45 McLAREN STREET, NORTH SYDNEY

PLANNING PROPOSAL
8TH NOVEMBER 2021

Also summarised is the evolution of the design since the lodgement of the original planning proposal in October 2020. This report presents an account of the formal feedback provided by council staff and includes a detailed analysis of how the revised design addresses each of the specific issues raised, including consistency with relevant policy or strategic documents.

COUNCIL'S REQUESTED AMENDMENTS

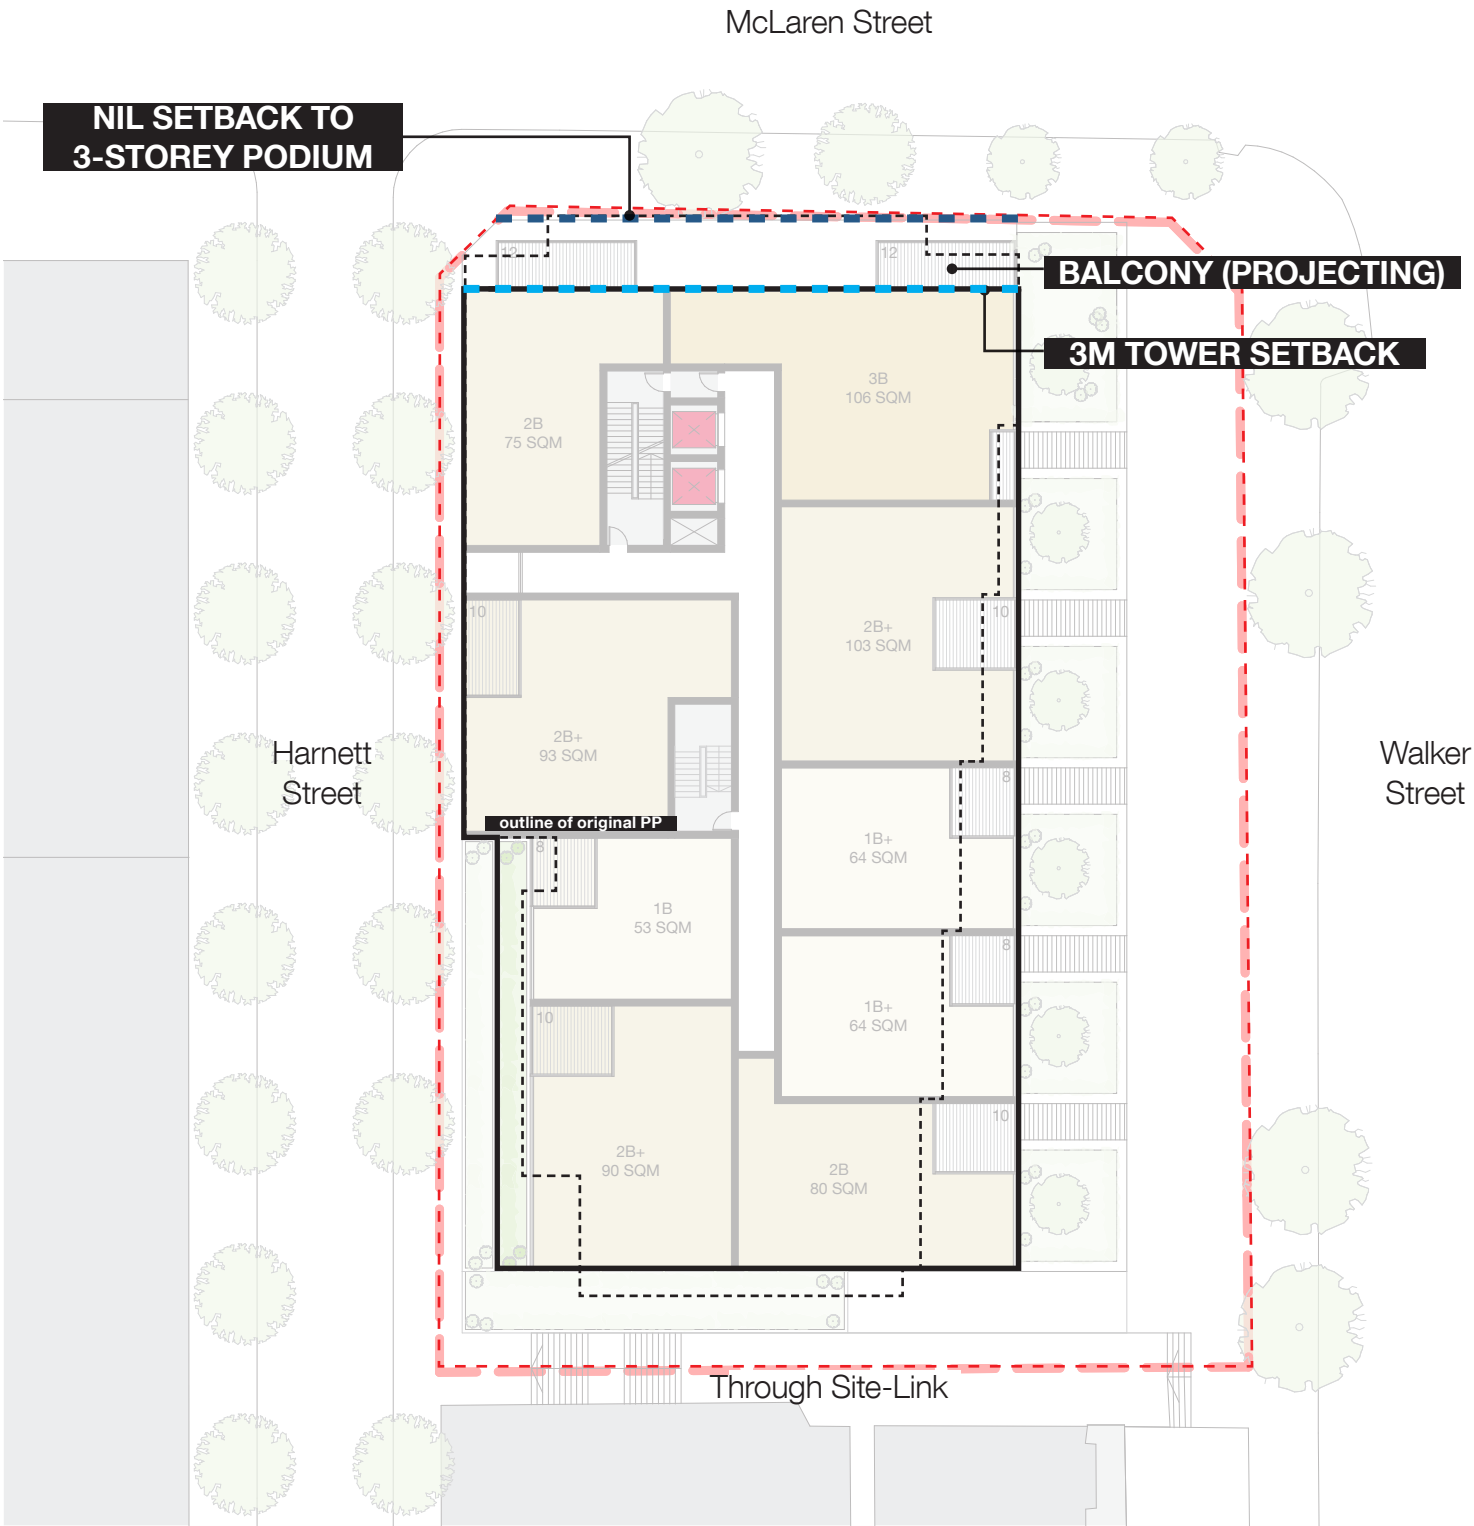
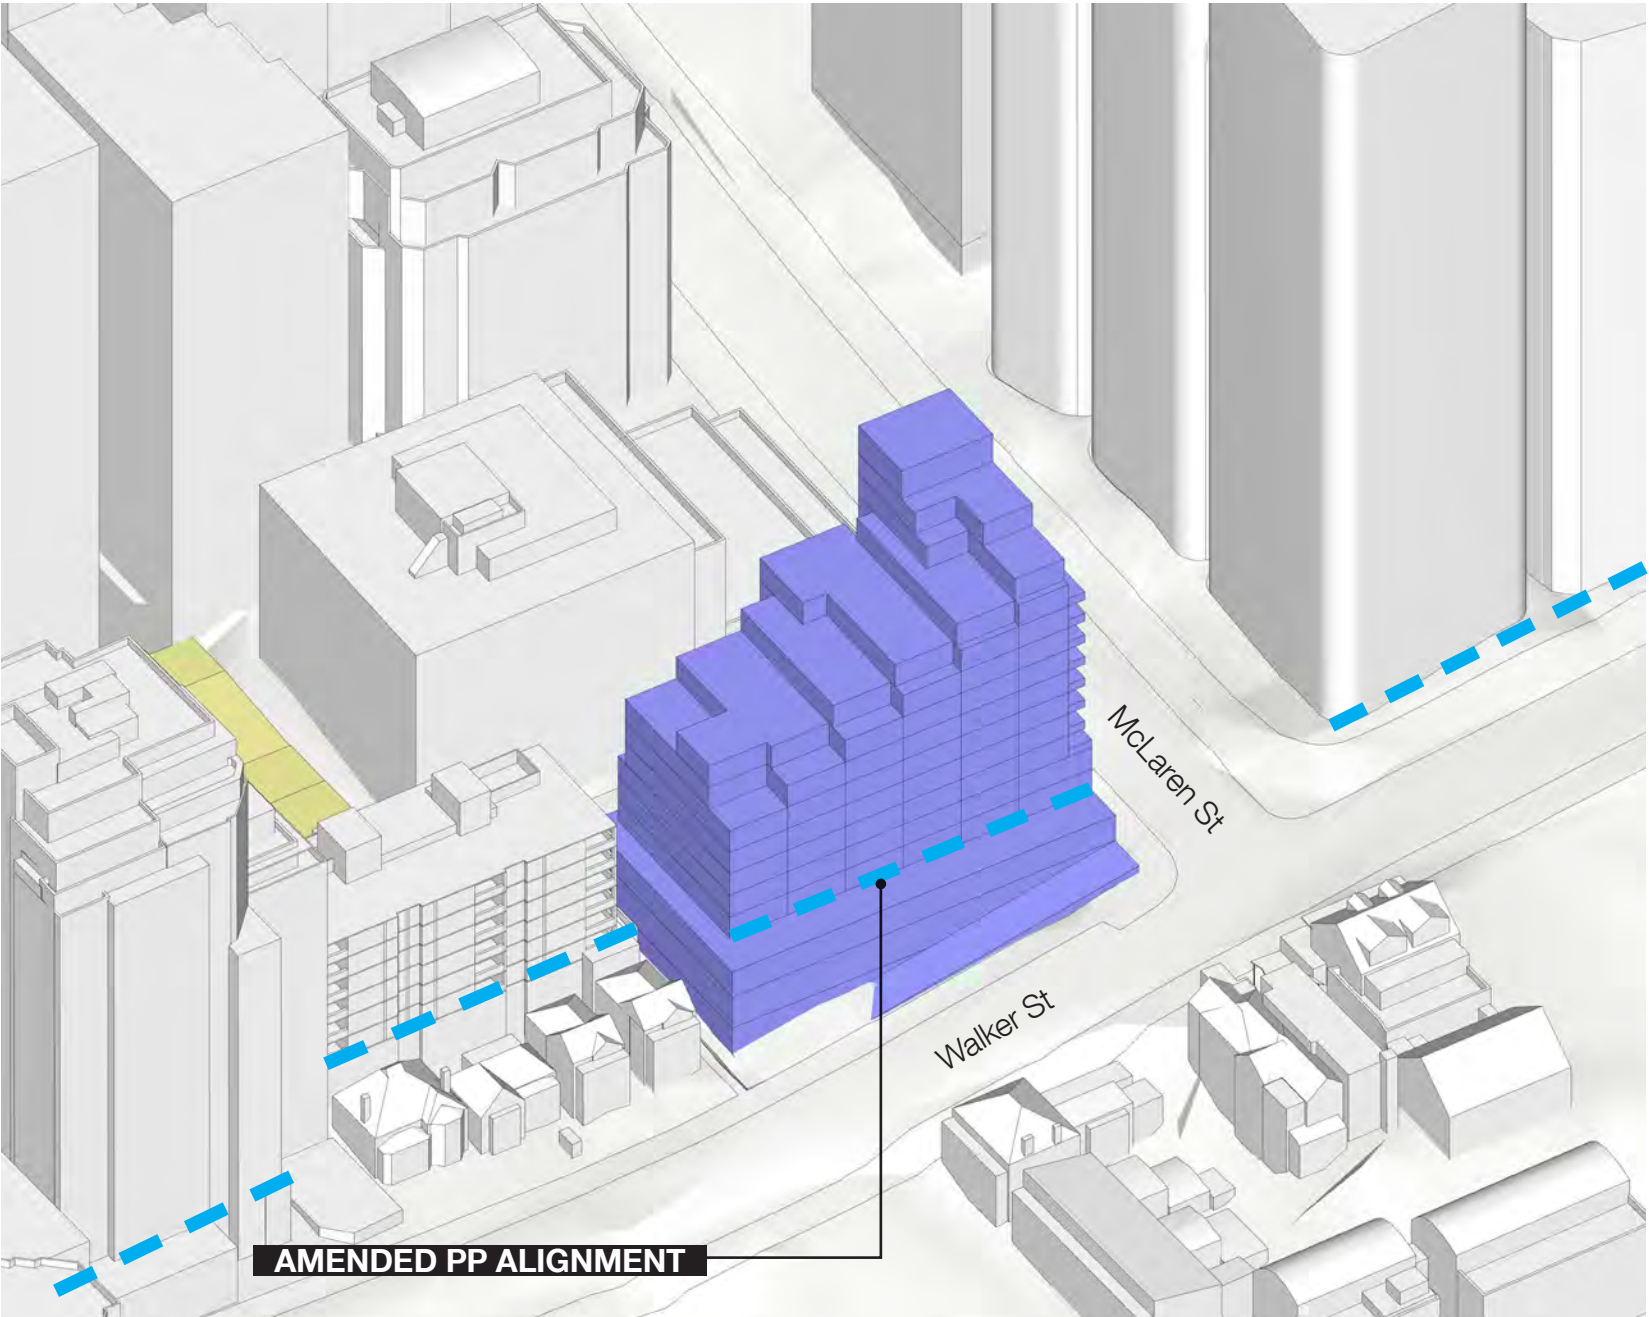
North Setback - introduce a 3-storey podium with nil setback and 3m tower setback to McLaren Street in accordance with the DCP provisions

Main tower form realigned to be parallel to Walker Street and relate to prevailing street wall.

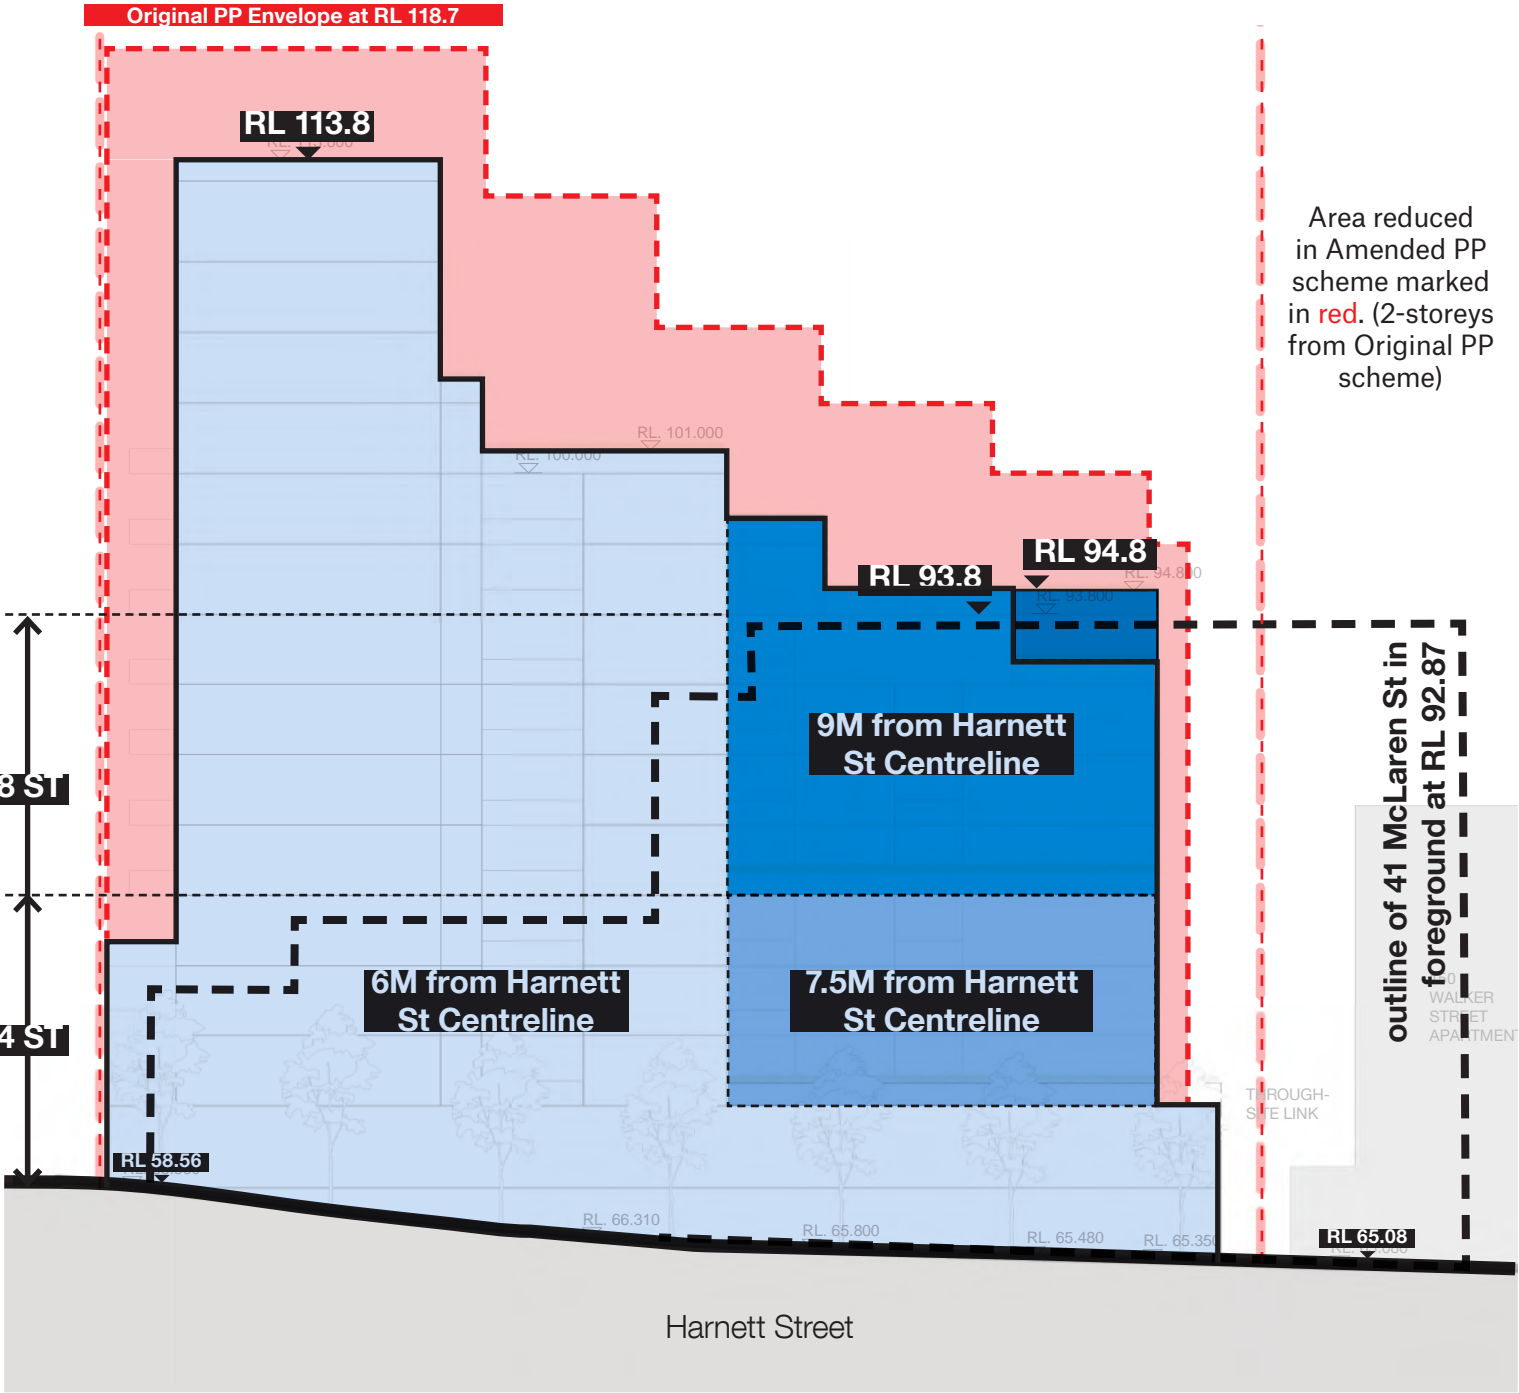
That the concept proposal be revised to:
(c) ensure that it is appropriately setback from the southern and western boundaries consistent with the minimum requirements set by the Apartment Design Guide to ensure adequate amenity to adjoining properties and internally within the development;
